**SUBDIVISION,
PLANNED UNIT DEVELOPMENT,
PLANNING APPROVAL, &
REZONING STAFF REPORT**

Date: November 17, 2011

Zion Baptist Church Subdivision

2514 Halls Mill Road
(Northwest corner of Halls Mill Road and Pollard Lane)

SITE PLAN

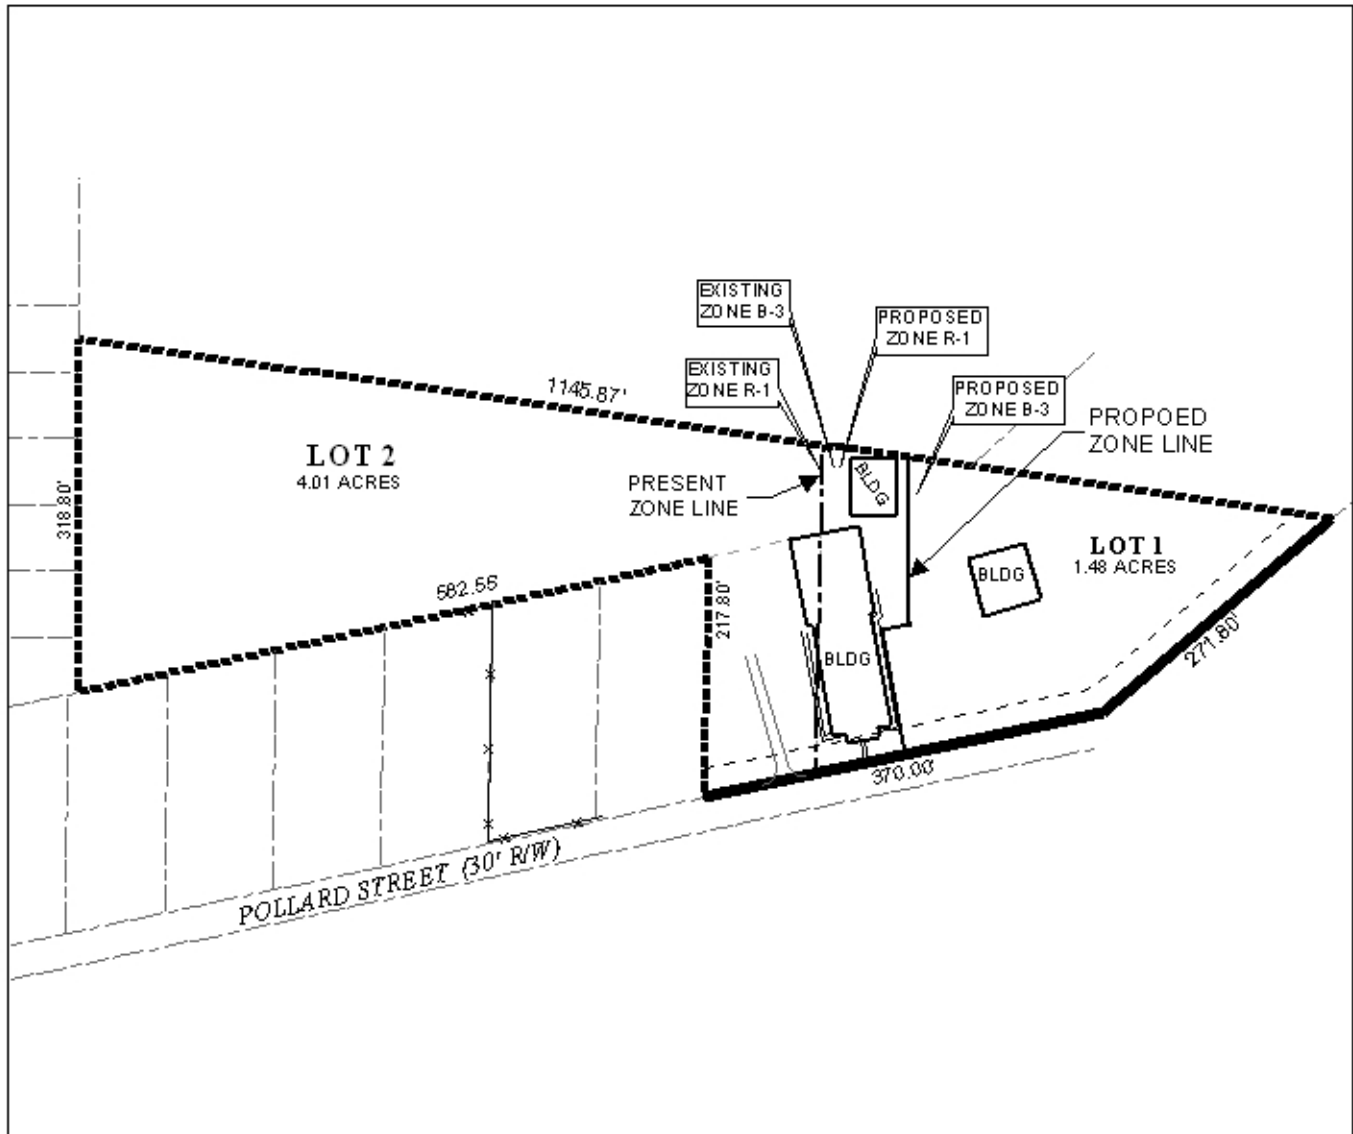
Driveway number, size, location, and design to be approved by Traffic Engineering and conform to AASHTO standards. Site plan does not illustrate adequate parking facilities and access for Lot 1 or Lot 2, therefore Traffic Engineering can not fully comment on recommendations.

The accompanying site plan is incomplete, in that, it does not indicate parking, dumpster location, landscaping & trees and lighting. Current aerials illustrate four curb cuts to the development, two to Halls Mill Road and two to Pollard Lane. Reduction of curb cuts would be an improvement to access, and a note should be placed on the Final Plat, if approved, however, the site plan submitted does not illustrate parking, access or curb cuts to the existing development.

Currently, the site is developed with three structures; however, the site plan does not illustrate uses associated with any structure nor any parking or other improvements. The applicant states in the application narrative the church (11,000 square feet) holds 300 people at full capacity. The applicant also states the parishioner's park on the side street and on grass located next to the church, which is accessed by an asphalt drive. Landscaping and trees are not illustrated on the site plan, which would illustrate the size and type of trees that could be used for credits and if the site meets the minimum requirements of the Ordinance. As such, full compliance with the landscaping and tree planting requirements of the zoning ordinance could be required.

While only Lot 2 is proposed to be zoned R-1, the applicant illustrates no improvements to the site, such as surface for parking, lighting, buffering and the provision of dumpster facilities. The site abuts a residentially zoned and developed district to the south and east, to the north is Maitre Park; as such, a buffer compliance with Section 64-4.D.1. of the Zoning Ordinance should be provided.

- 1) submittal of an acceptable, detailed narrative describing the project in detail as required in Section 64-5.D. of the Zoning Ordinance;
- 2) revision of the site plan to show **ALL** improvements on the site, including, but not limited to, dimensions of parking stalls or drive aisles, indicate paving materials, and indicate the seating capacity of the church and other information needed to ensure parking compliance;

- 1) submittal of an acceptable, detailed narrative describing the project in detail as required in Section 64-5.D. of the Zoning Ordinance;
- 2) revision of the site plan to show ALL improvements on the site, including, but not limited to, dimensions of parking stalls or drive aisles, indicate paving materials, and indicate the seating capacity of the church and other information needed to ensure parking compliance;
